CITY OF WESTMINSTER			
PLANNING APPLICATIONS COMMITTEE	Date 6 September 2016	Classification For General Release	
Report of Director of Planning		Ward(s) involved Abbey Road	
Subject of Report	Carlton Court, 120 Maida Vale, London, W9 1QA,		
Proposal	Demolition of existing five storey building and out buildings and erection of a part five and part three storey serviced apartment hotel building (Use Class C1) with restaurant and spa facilities in newly excavated basement and erection of single storey stair structure in rear garden to provide access to the basement.		
Agent	Mr Amin Taha		
On behalf of	Honosa Ltd		
Registered Number	16/05230/FULL	Date amended/ completed	22 June 2016
Date Application Received	3 June 2016		
Historic Building Grade	Unlisted (but adjacent to grade II listed buildings to the south)		
Conservation Area	St John's Wood

1. RECOMMENDATION

Refuse permission - design, amenity, overheating/ventilation and trees.

10. KEY DRAWINGS

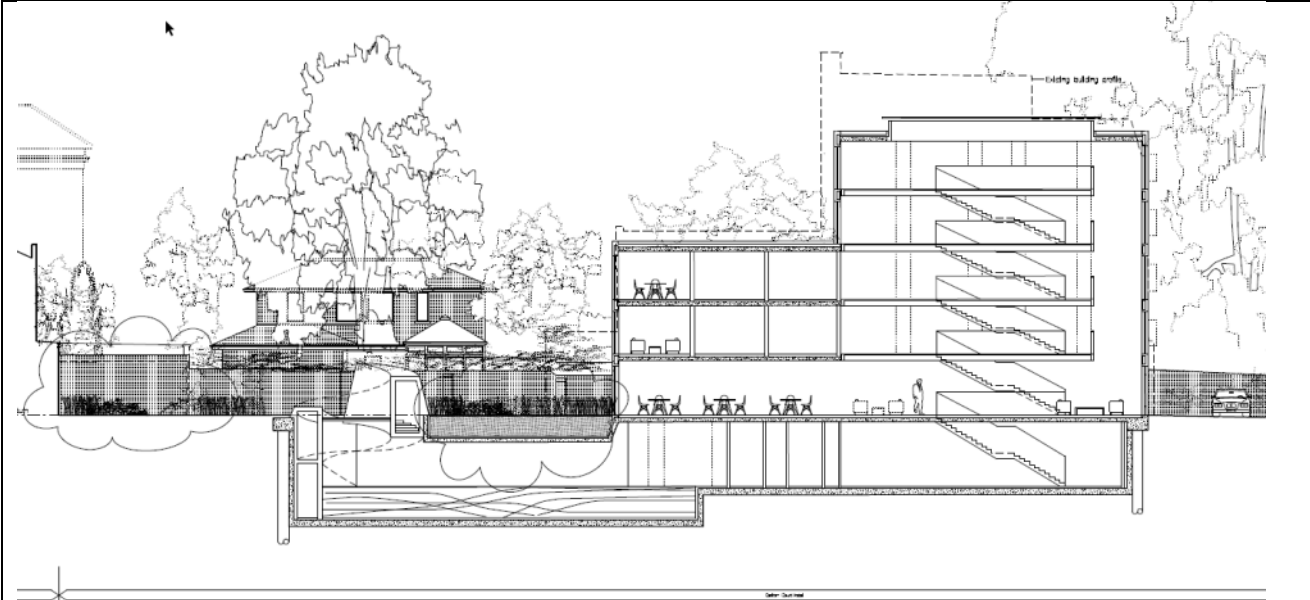
The principal issue of concern with regards to the new building proposed is in relation to its architectural approach and quality, and in this respect the scheme is considered unacceptable. Though the submitted plan drawings show a quite different arrangement of building in terms of scale and positioning of the windows, the elevations and visual perspective submitted appear to largely tally with each other, and these show a highly striking new development.

The basic design approach of the building is for each elevation to comprise a continuous grid of particularly large windows set into and slightly recessed behind a relatively slender framework of yellow stock brickwork. Overall, the building is not considered appropriate in terms of its design to make a positive contribution to the character of the townscape of Maida Vale. Notwithstanding that the building is proposed for a hotel use, it nonetheless stands out unacceptably in context with the more low key residential uses predominating in the surrounding area, and in officers consideration appears with a scale of window opening and with a styling/visual impression giving it a more industrial aesthetic and more overtly commercial character, rather than one more successfully integrated to the Maida Vale townscape where the strongly defined pattern to the street is for buildings to have a more restrained architectural character with a greater visual solidity to their elevations.

The front and rear elevations have a variation to the window grid not found to the side elevations, with the two bays flanking the pair of central windows to each floor level being notably narrower than the surrounding windows. The impression is somewhat lost to the rear as this design detail is not carried through onto the rear extension, though on the front it is readily appreciable and is emphasised further by the projecting oriel windows being found only on the outer pair of bays. Though this rhythm of bays introduced into the composition of the front elevation adds some interest, the remainder of the elevations largely have an impression of an undifferentiated grid of windows which in its repetitive nature and large scale of window openings is not considered appropriate. There is also little distinction given to the treatment of any of the floor levels with regards to a differentiation in design or use of differing brickwork textures or bonding patterns (for instance) to give the composition a defined base or strong definition of floor levels, and also no clear sense of a strongly defined termination of the roofline to the façade (with this parapet line further cluttered by the prominent railings shown to the edge of each façade on the elevation drawings). This largely unelaborated brickwork facing together with the scale and repetitive nature of the window openings gives an overall impression of a rather monolithic block with an overly imposing architectural unity, especially given that the approach is taken onto the side elevations (and therefore around the entire development) where the standard pattern in the area is for buildings to have a more restrained approach to side elevations differentiating the appearance of the building as it responds to the varying site conditions to each elevation (also in

The scale of the windows is particularly striking, and is considered out of character with the surrounding townscape context, and particularly when seen in context with the run of listed buildings to the south, including the paired villa building at nos. 116-118 to the immediate south side of this site. The windows are very considerably larger than the much smaller sash window proportions of this pair of listed buildings to the south side, and the proximity and striking nature of the new building proposed would unacceptably impact upon the setting of those listed buildings.

It is noted however that though the drawings do not show such features, the new building is likely to incorporate a new lift overrun and new plant structure to the main roof level (as noted elsewhere within this report) and some drawings do show railings around the parapets and a very large 'V' shaped projecting roof structure, and whilst these may not be anticipated to be of the bulk of the existing plant room/lift structure they could nonetheless represent unattractive structures likely to clutter the roofline of the building.

The north elevation drawing submitted with the application incorrectly indicates the existing building line, as it shows that the proposed bulk is similar to existing, however the plans show that the building is to be built out further as outlined above, the submitted information is therefore conflicting. On the basis that the plans are correct, given that they show the internal arrangement of the rooms, the additional bulk, namely at third floor level, will have an impact on the amenity of neighbouring residents, particularly Greville Hall to the north which has windows looking onto the site. Two objections have been received from residents within this block.

- c) The drawings amended so that they correlate. For example the plans do not correlate with the elevations in terms of the fenestration locations or sizes or the size and location of the building (particularly when comparing the East elevation to the plans).
